SUBJECT: Responds to 840814 draft safety evaluation of inadequate core cooling instrumentation sys, per NUREG-0737, Item II, F.2. Addl info, implementation milestones, & implementation rpt for reactor vessel level monitoring sys encl.

Re: Turkey Point Units 3 & 4  
Docket Nos. 50-250 and 50-251  
Inadequate Core Cooling Instrumentation (ICCI) System  
NUREG-0737, Item II.F.2

RESPONSE TO NRC REQUEST FOR ADDITIONAL INFORMATION  
ON THE ICCS  
(ENCLOSURE I)

TURKEY POINT UNITS 3 & 4  
QUALIFIED SAFETY PARAMETER  
DISPLAY SYSTEM (QSPDS)  
BLOCK DIAGRAM  
FLORIDA POWER & LIGHT COMPANY

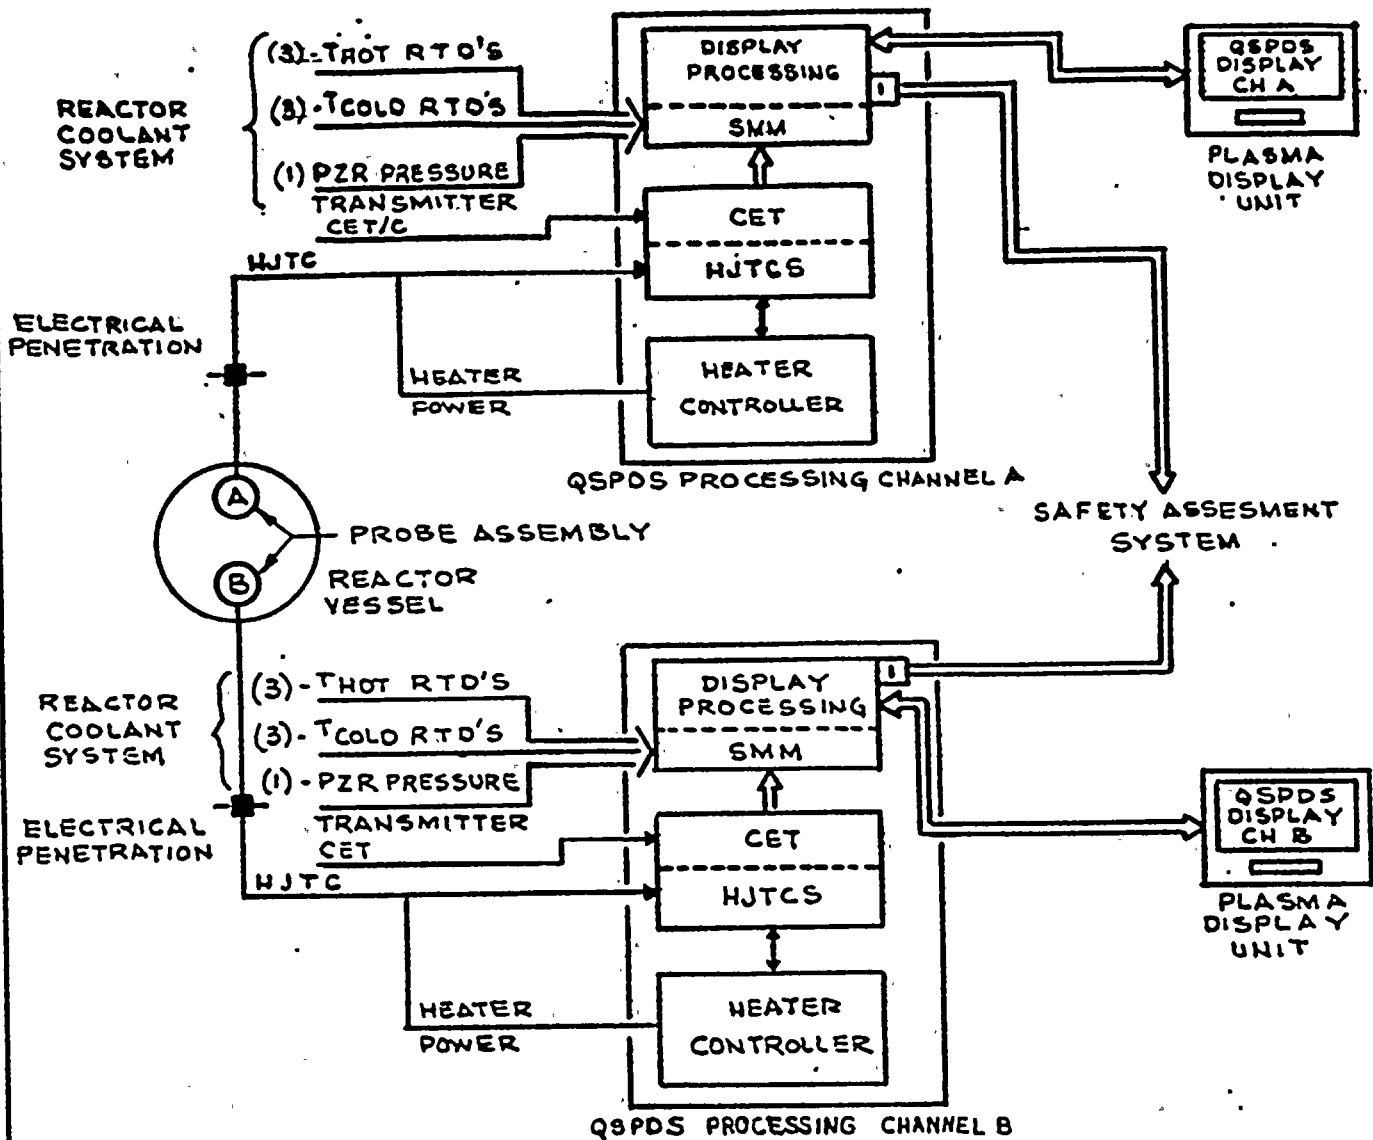
1. Show schematically the final ICC instrumentation system and identify any deviations from the Appendix B to NUREG-0737 design requirements. Also, provide a detailed description of the power supply for ICCI and proposed upgrading plans with a completion schedule with respect to station Class 1E power sources stated in NUREG-0737, Appendix B, Criterion 3.

The final ICCS schematic is shown on Fig. 1 (attachment 1). The only deviation from Appendix B to NUREG-0737 design requirements is the Power Supply for the ICCS.

The Inadequate Core Cooling System is presently powered from panels 3(4)C202A and 3(4)C203A. These safety related panels are powered from the vital portion of MCC's 3(4)B and 3(4)C.

In the event of a loss of offsite power, there will be momentary interruption of power to the ICCS until the MCC's are automatically sequenced onto the diesels. The ICCS can tolerate a power loss without "crashing" the system. The ICCS functions will be lost during the power loss only. Upon restoration of power, the system will automatically come back into operation.

The present power supplies represent an interim configuration until the Vital Inverters of Turkey Point are replaced. At that time, the ICCI will be transferred to the 120 volt vital a.c. system and powered from the Vital Instrumentation panels. These panels are fed from the Vital Inverters which are normally fed from the battery chargers and backed up by the safety related plant batteries.
